BEFORE THE GUAM PUBLIC UTILITIES COMMISSION

IN THE MATTER OF:) GPA Docket 20-16
)
The Application of the Guam Power)
Authority Requesting to Retire Piti 8 & 9) **ALJ REPORT**
Units and to Procure 60MW of Renewable)
Energy.)
_____)

PITI (MEC) 8 & 9 ULSD CONVERSION

MEC COMMENTS

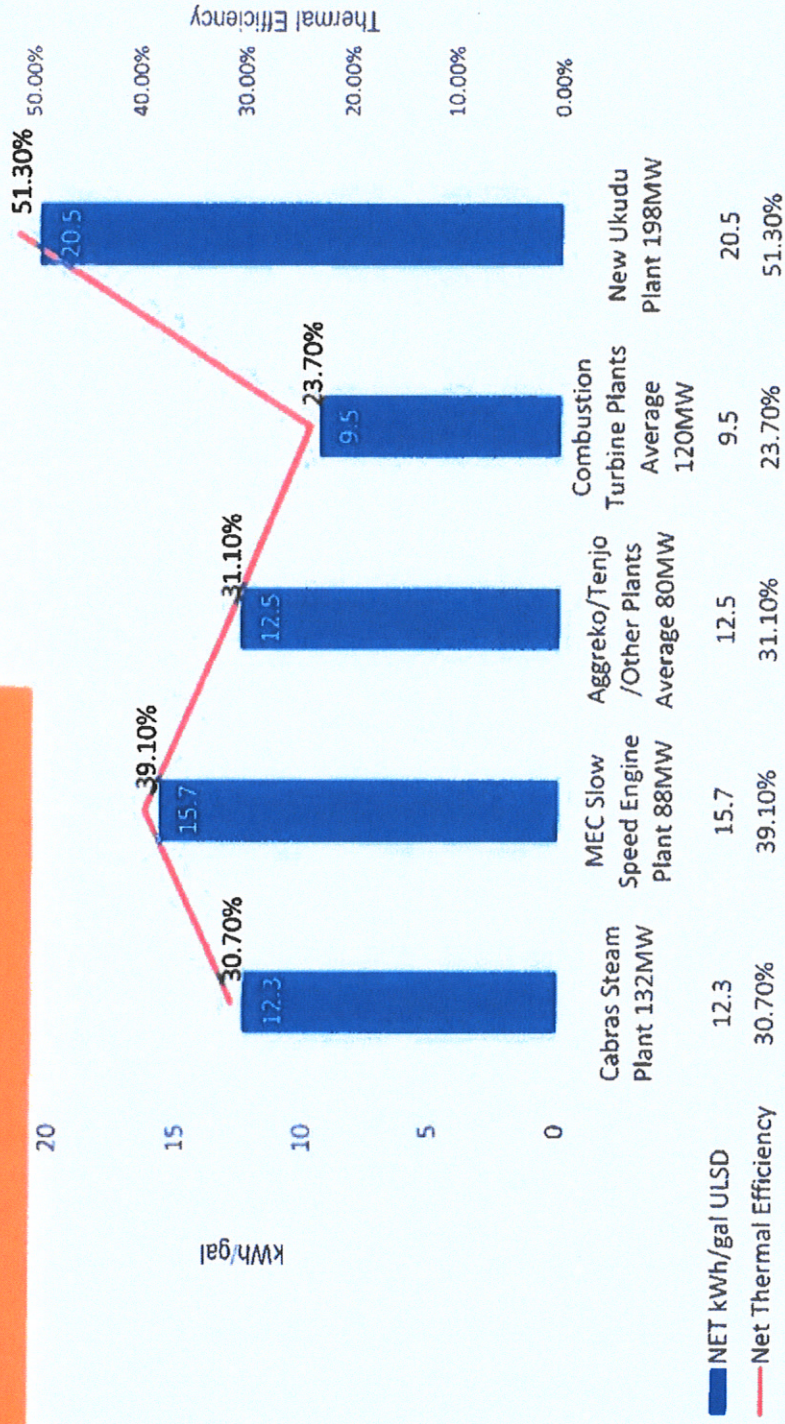
MEC's Comments: This is a significant and unjustified drop from \$12M to \$5M. It is very unclear what is included in this figure. Urea alone is \$0.7 Million a year. 40 small size units, means more moving parts and more maintenance – more people.

A price of 5.5 MUSD seems extremely low. Aggreko pricing is usually in the range 20.000 USD/MW per month in capacity charge, which sums to 9.1 MUSD for 40 MW per year. In addition they charge around 8 USD/MWh produced in energy charge, excl. fuel and lubrication oil. Lubrication oil costs would be around 275.000 USD per year additionally, based on 0,8 g/kWh and 3 EUR/kg system lube oil costs. It sounds very odd that the annual Aggreko O&M costs can drop from 12 MUSD to 5,5 MUSD. Before taken such an important decision, the figure has to be verified and it must be determined what is actually included in the 5,5 MUSD.

The Aggreko Units would require full overhaul at 25,000 – 30,000 hours (which would extend their lifetime by 15,000 - 20,000 hours). The budgetary cost for this is \$10-15m, and by looking at the accumulated running hours, it seems that the units are approaching this by early 2021.

MEC's Recommendations:

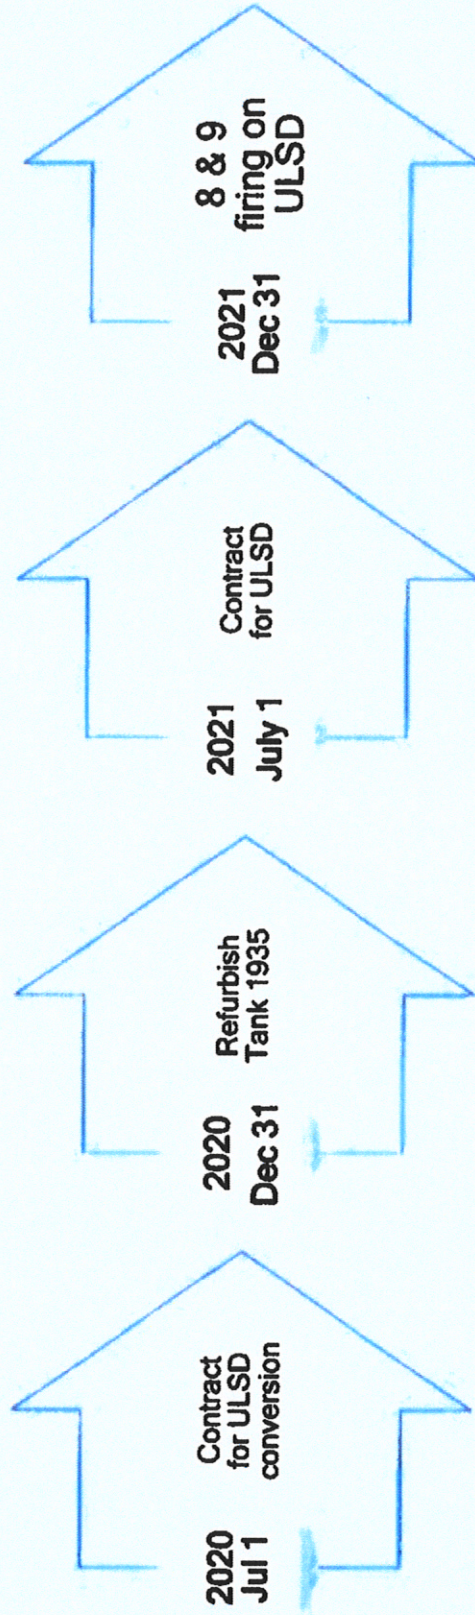
Retaining Piti 8&9 plant as intermediary load plant is the best overall solution for Guam since:

- Guam Piti after conversion complies with US EPA legislation
- It is the most financially attractive option
- It retains a higher capacity reserve in case of unforeseen delays in the capacity expansion of renewables and others at a very attractive thermal efficiency.
